# SERVICE BULLETIN

TITLE Rudder and Elevator Leading Edge

BULLETIN NO. 228

MODELS AFFECTED: 108 (Voyager)

Typical Rudder Assembly Section

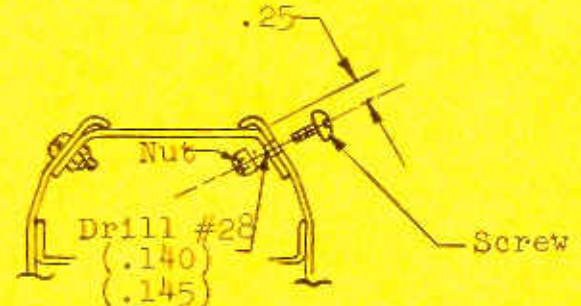
**RUDDER** - Remove the rudder. The control cables of the rudder are held in tension by springs and it is not necessary to slacken the turnbuckles to detach cables from rudder. The seven clips are to be located as shown on Figure 1. Drill .098 holes for rivets (#40 Drill).

Drill .125 inch diameter holes at junction of spar flange and rib flange and saw-cut both cover sheets to hole along flange of rib as shown on Figure 1.

Saw-cut Sheets to  
.125 Dia. Relief Hole

Typical Elevator Assembly Section

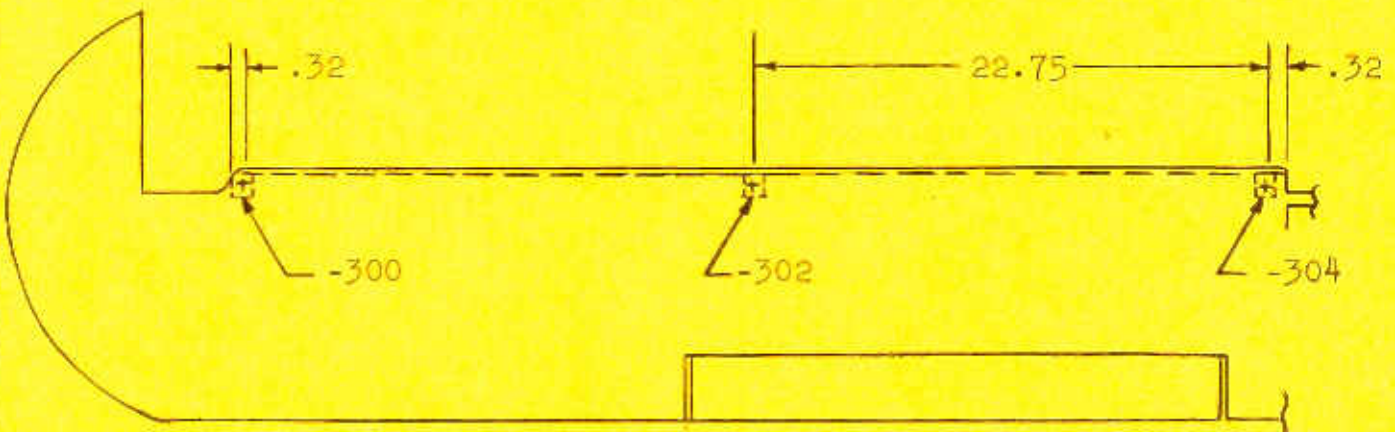
**ELEVATOR** - Remove the elevator panels. Removing the bolts through central hinge and control horn will permit removal of each panel without disturbing the elevator control cables. Disconnect trim tab flexible shaft at trim tab horn and detach shaft housing from elevator. Attach three clips to each panel as shown on Figure 2. Drill .141 holes for screws (#28 Drill).
